CITY OF Tulsa

Board of Adjustment

Case Number: BOA-23624

ACTION REQUESTED: Special Exception to allow an Accessory Dwelling Unit in an RS-1 District (45.031-D)

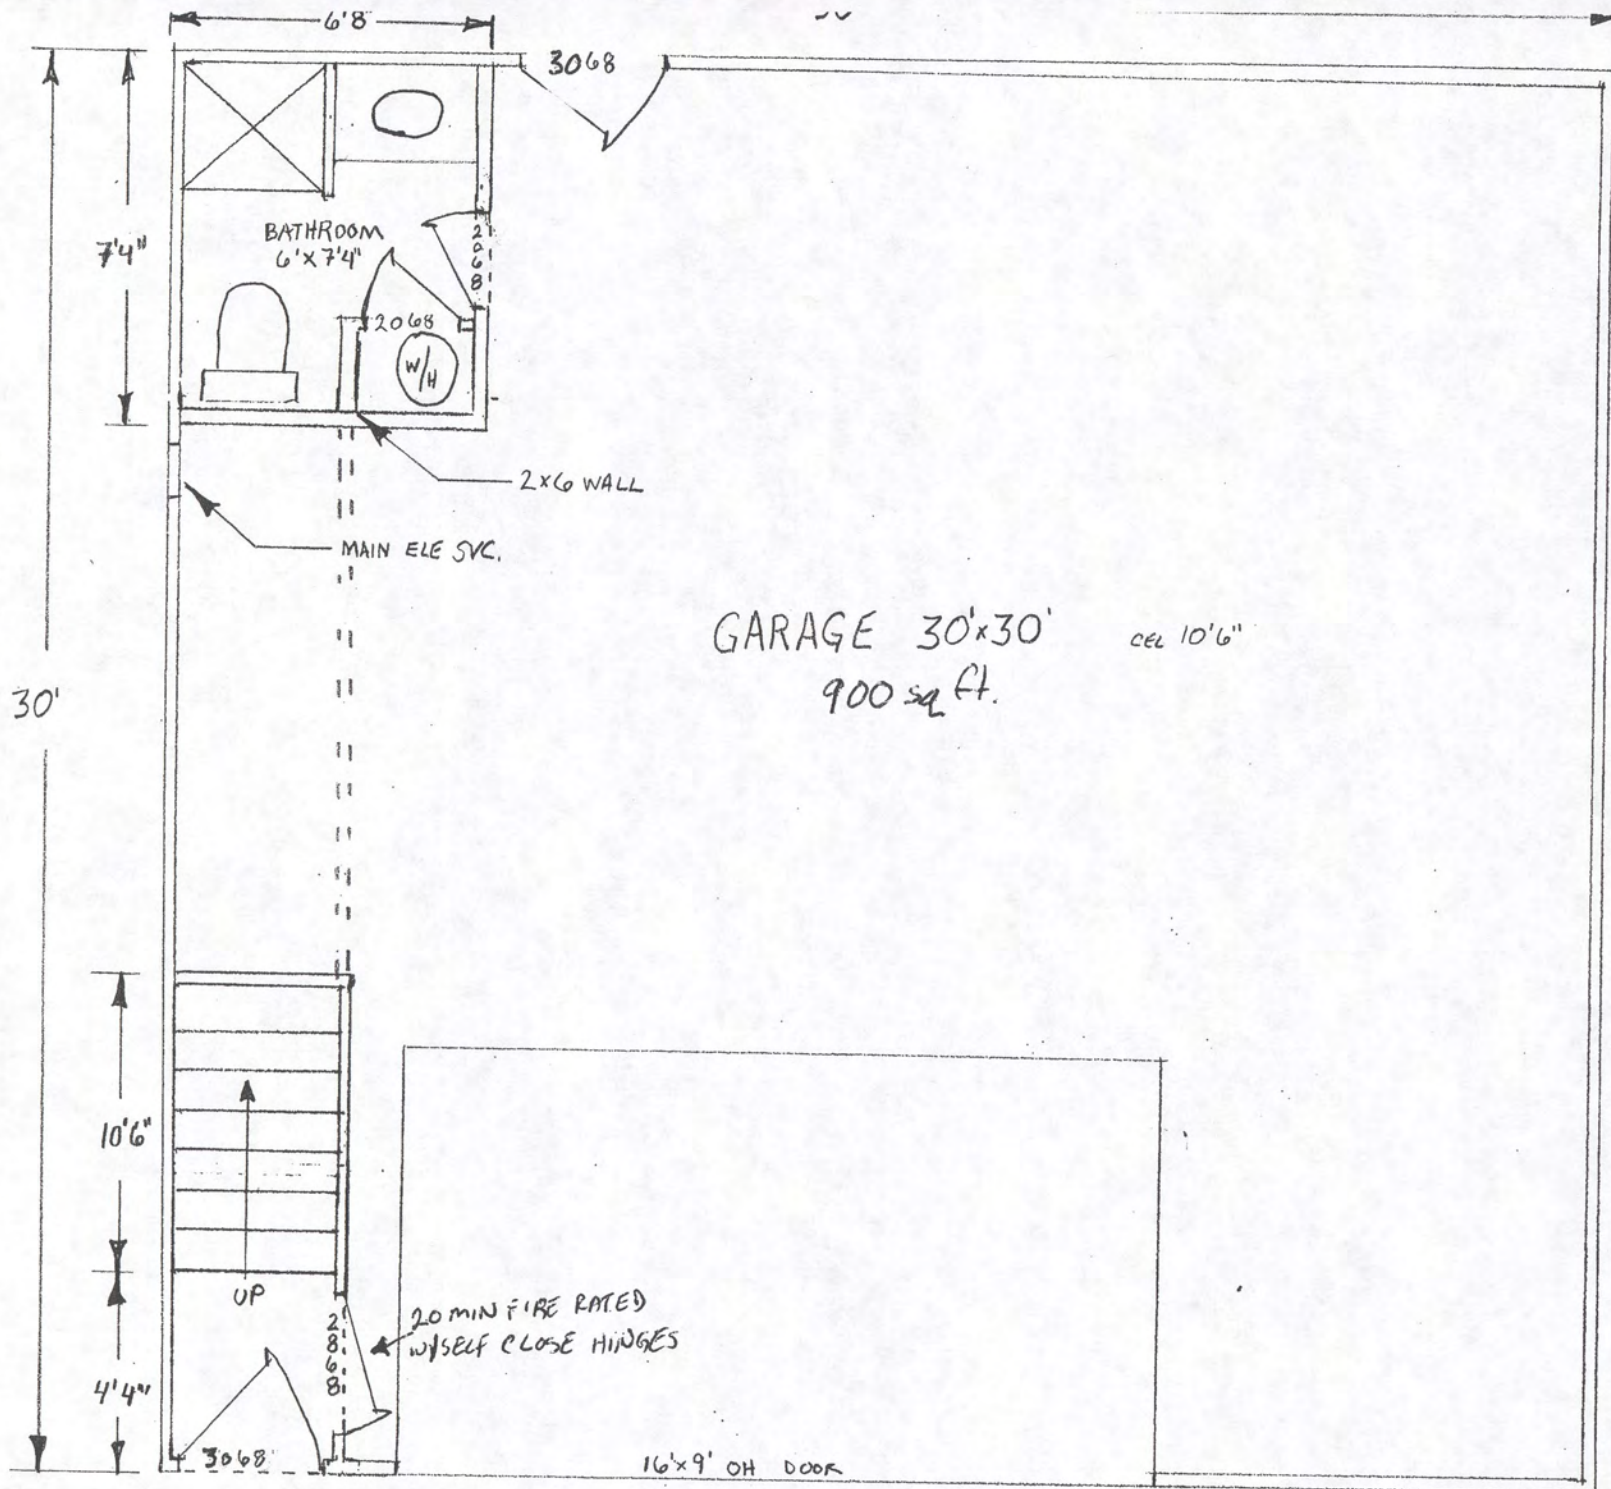
R302.6 Dwelling-garage fire separation. The garage shall be separated as required by Table R302.6. Openings in garage walls shall comply with Section R302.5. Attachment of gypsum board shall comply with Table R702.3.5. The wall separation provisions of Table R302.6 shall not apply to garage walls that are perpendicular to the adjacent dwelling unit wall. Review Comment: 5/8" type X gypsum is required on the garage ceiling to separate it from habitable space above; note this on the plans.

R311.2 Egress door – Amendatory. Not less than one egress door shall be provided for each dwelling unit or garage. The egress door shall be side-hinged and shall provide a clear width of not less than 32 inches (813 mm) where measured between the face of the door and the stop, with the door open 90 degrees (1.57 rad). The clear height of the door opening shall be not less than 78 inches (1981 mm) in height measured from the top of the threshold to the bottom of the stop. Other doors shall not be required to comply with these minimum dimensions. Egress doors shall be readily openable from inside the dwelling or garage without the use of a key or special knowledge or effort. Review Comment: Please revise the man door on the south side of the garage to be a 3' door.

R302.5.1 Opening protection. Openings from a private garage directly into a room used for sleeping purposes shall not be permitted. Other openings between the garage and residence shall be equipped with solid wood doors not less than 13/8 inches (35 mm) in thickness, solid or honeycomb-core steel doors not less than 13/8 inches (35 mm) thick, or 20-minute fire-rated doors, equipped with a self-closing or automatic closing device. Review Comment: Please revise the plans to show that the first floor door between the garage and stairs will be a fire rated door that is self-closing.

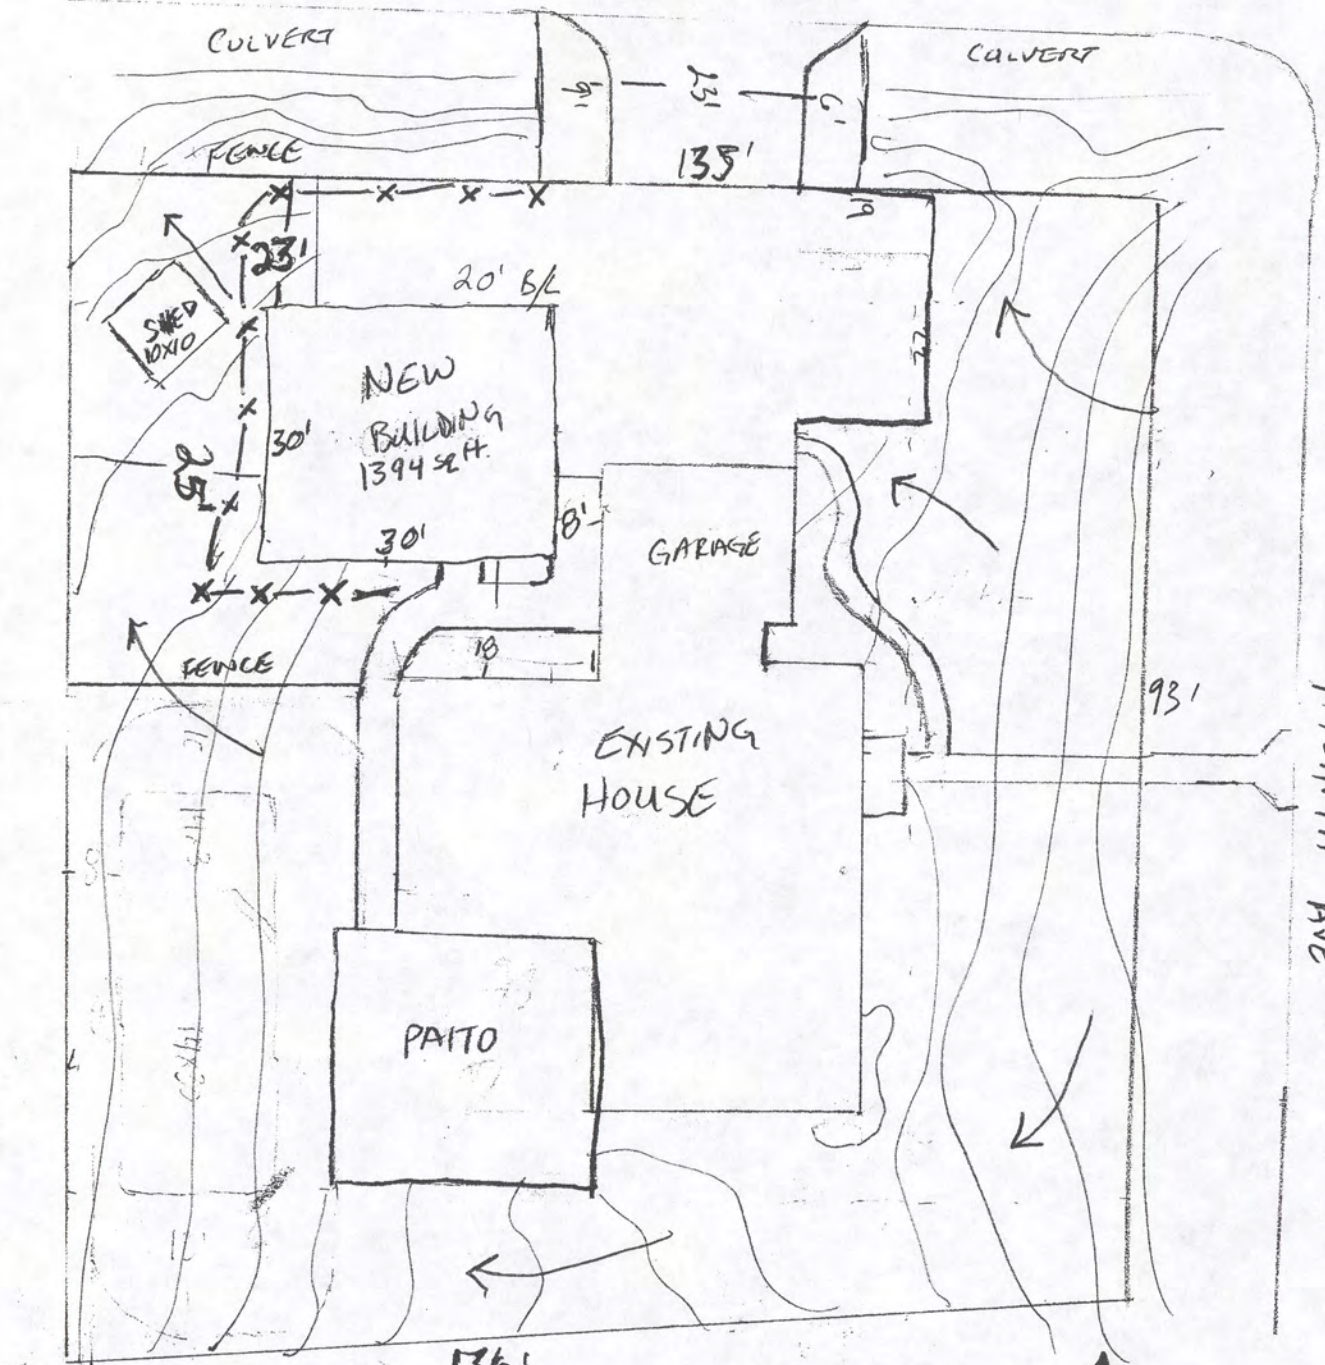
All developments shall be designed, constructed, and completed in a manner which minimizes the exposure of bare earth to precipitation. Revise site plan to show an Erosion Control Plan containing detailed location of all silt fence and other erosion and sedimentation control methods to be used during construction per City of Tulsa Standard 126.

Section 55.090-F Surfacing. In RE and RS zoning districts, driveways serving residential dwelling units may not exceed 50% of the lot frontage or the following maximum widths, whichever is less, unless a greater width is approved in accordance with the special exception procedures of Section 70.120, or, if in a PUD, in accordance with the amendment procedures of Section 30.010-I.2. (Refer to the City of Tulsa Standard Specifications and Details for Residential Driveways #701-704). Review Comments: Per this section, the maximum driveway width allowed on

your lot and in the street setback area is 30'. It appears that you are expanding the driveway to be more than 30' wide within the street setback area. You may either revise the plans to show the driveway will be no wider than 30' in the street setback, or you may request a special exception for a driveway that exceeds 30' of width in an RS-1 zoning district.

Section 45.030-A.1 Accessory Building Size, RE and RS-1 Districts. In RE and RS-1 districts, the total aggregate floor area of all detached accessory buildings, including accessory dwelling units, and accessory buildings not erected as an integral part of the principal residential building may not exceed 750 square feet or 40% of the floor area of the principal residential structure, whichever is greater. Review Comments: The aggregate floor area (attached garage and house, but not porches, per Section 90.040) of the principal residential structure appears to be 3,764 sq. ft. Based on the floor area of the house, 1,506 sq. ft. (3,764 x 40%) of detached accessory structure floor area is allowed on this lot. No dimensions are shown for the shed, but appears that both floors of the proposed detached building plus the existing shed exceeds 1,506 square feet. Floor area is measured from exterior faces of exterior walls. Please revise the plans to show that the aggregate floor area of proposed and existing detached accessory buildings will not exceed 1,506 square feet.

Section 5.030-A, Table of Regulations. The lot and building regulations of Table 5-3 apply to all principal uses and structures in R districts, except as otherwise expressly stated in this zoning code. General exceptions to these regulations and rules for measuring compliance can be found in Chapter 90. Regulations governing accessory uses and structures can be found in Chapter 45. Review Comments: The proposed detached building requires a 25 foot rear setback from the west property line in an RS-1 zoning district. You may revise the plans to provide a setback of 25' from the west property line, or as an alternative you may request an administrative adjustment from INCOG to reduce a rear setback in an RS-1 district by up to 20%.
